MILITARY PRISON CONSERVATION WORKS SOUTH ELEVATION SMC

BUILDING	Edinburgh Castle
PROJECT	Military Prison Conservation Work to Military Prison

PROJECT DRAWING NUMBER	PIC222R-OER-SMC-20230815-10005-V0100-Sou
SCALE	1:100 @ A3
DATE	15th August 2023
ARCHITECT	Bruce Chandler
DRAWN BY	David Nicol
ARCHIVE NUMBER	-----

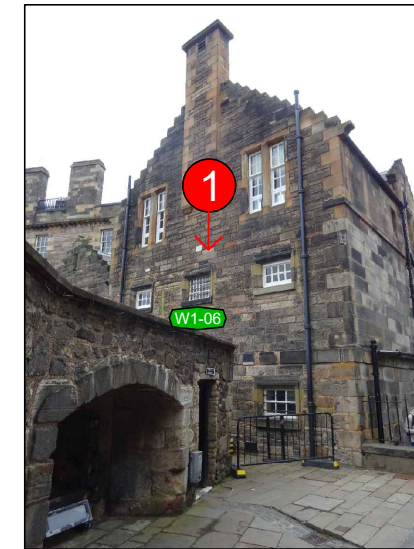
Stone indent required below W1-08

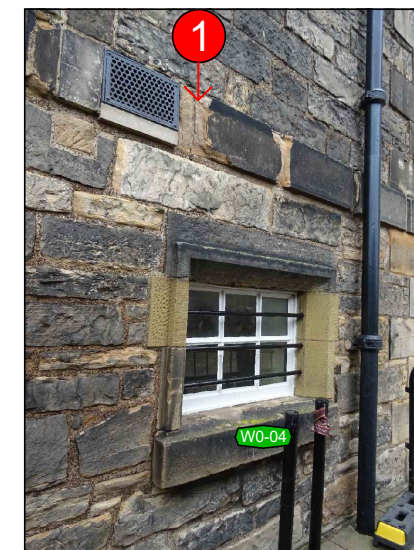
South elevation with location of stone indent required above W1-06

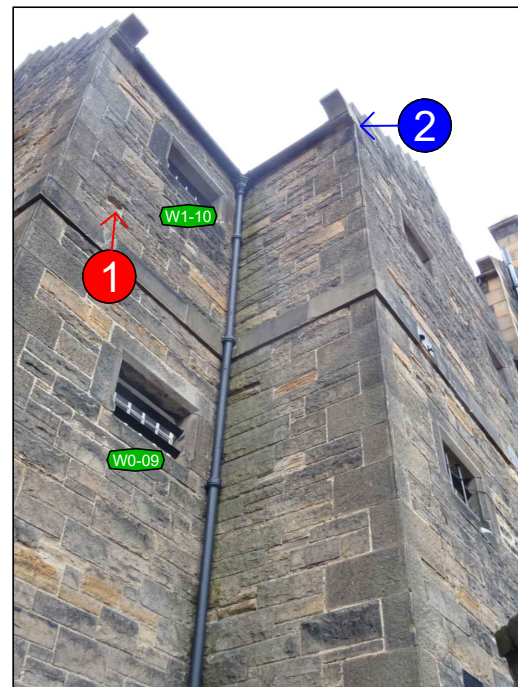
Indent required above W0-04 on string course

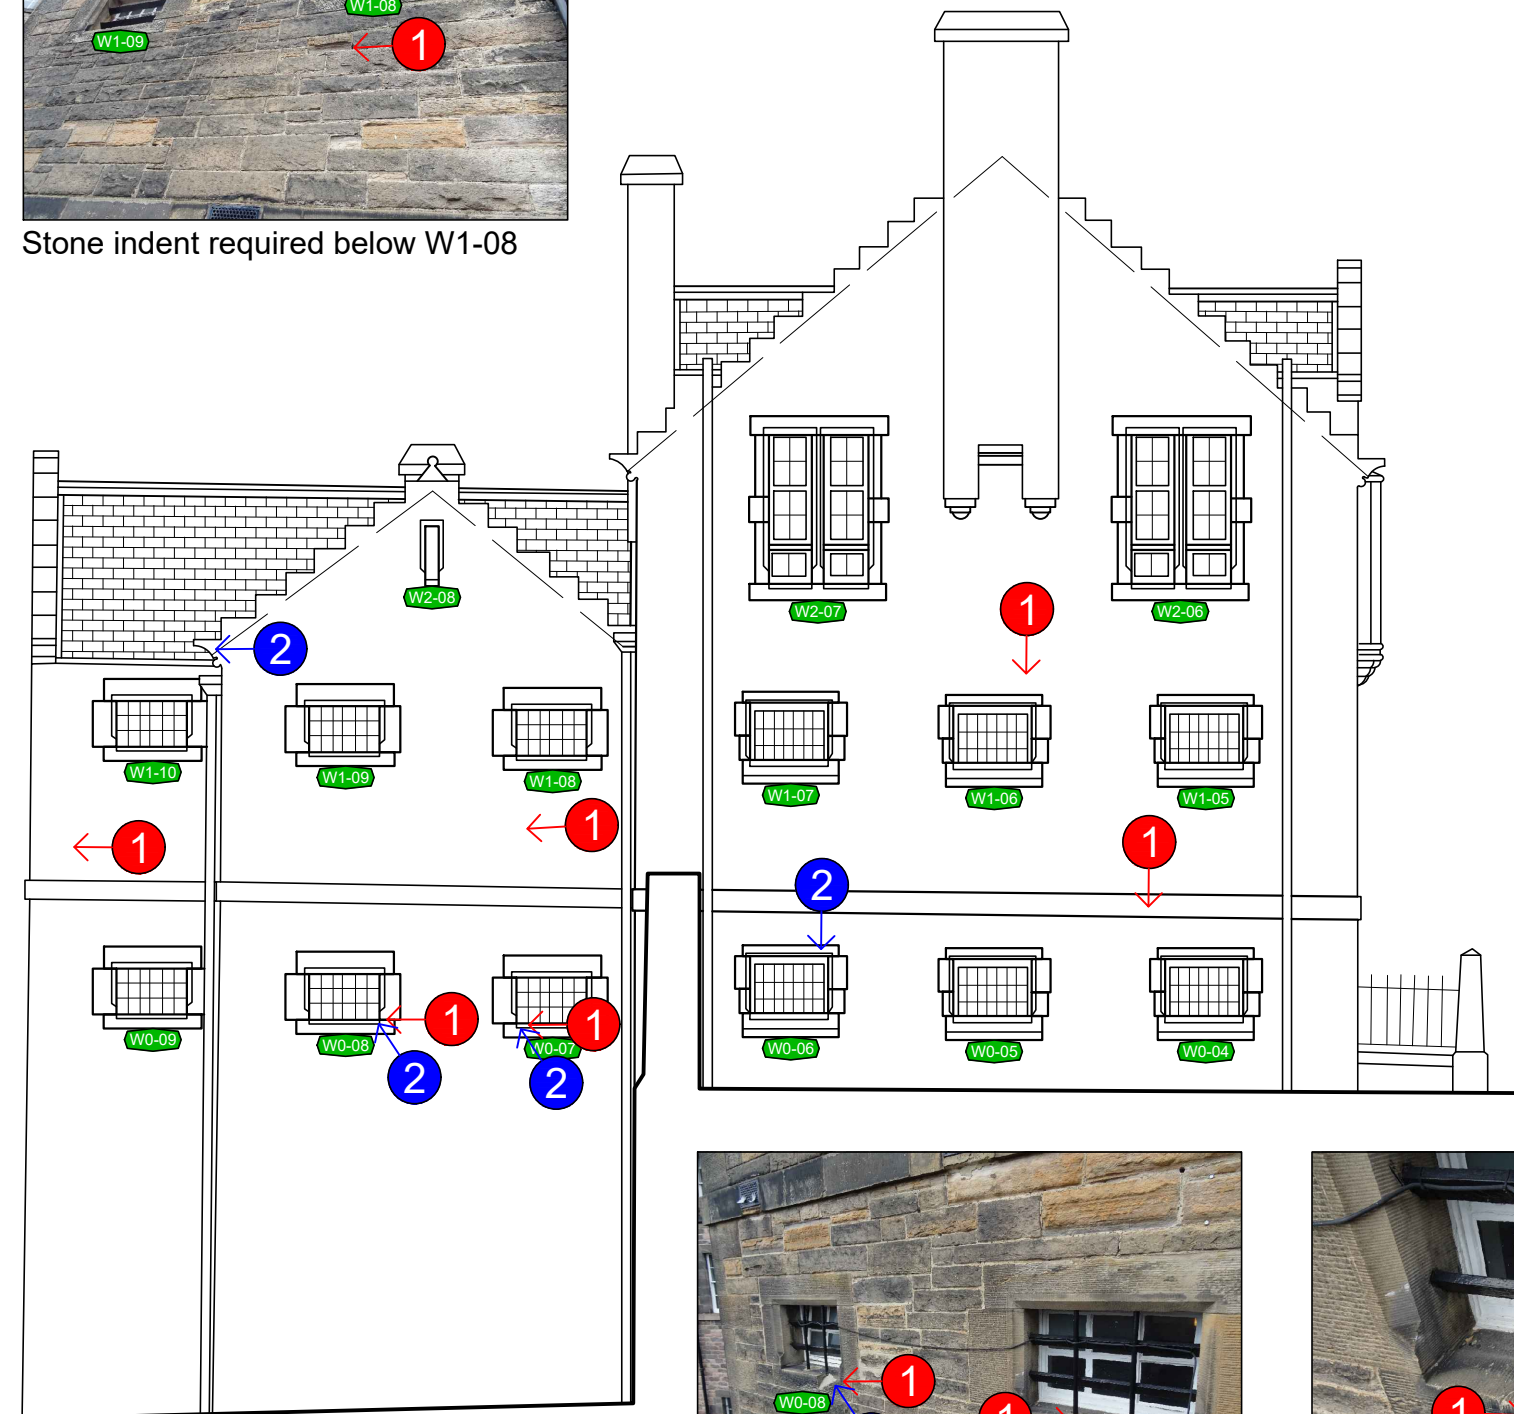
Location of stone indent required below W1-10, and fractured stone on the stepped gable

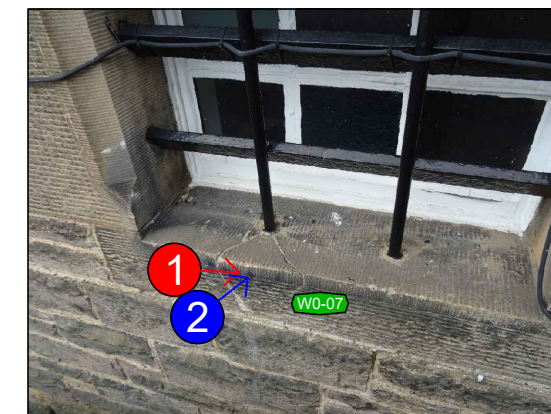
Fractured stone and indent required at both W0-08 and W0-07

Fractured cill at W0-07
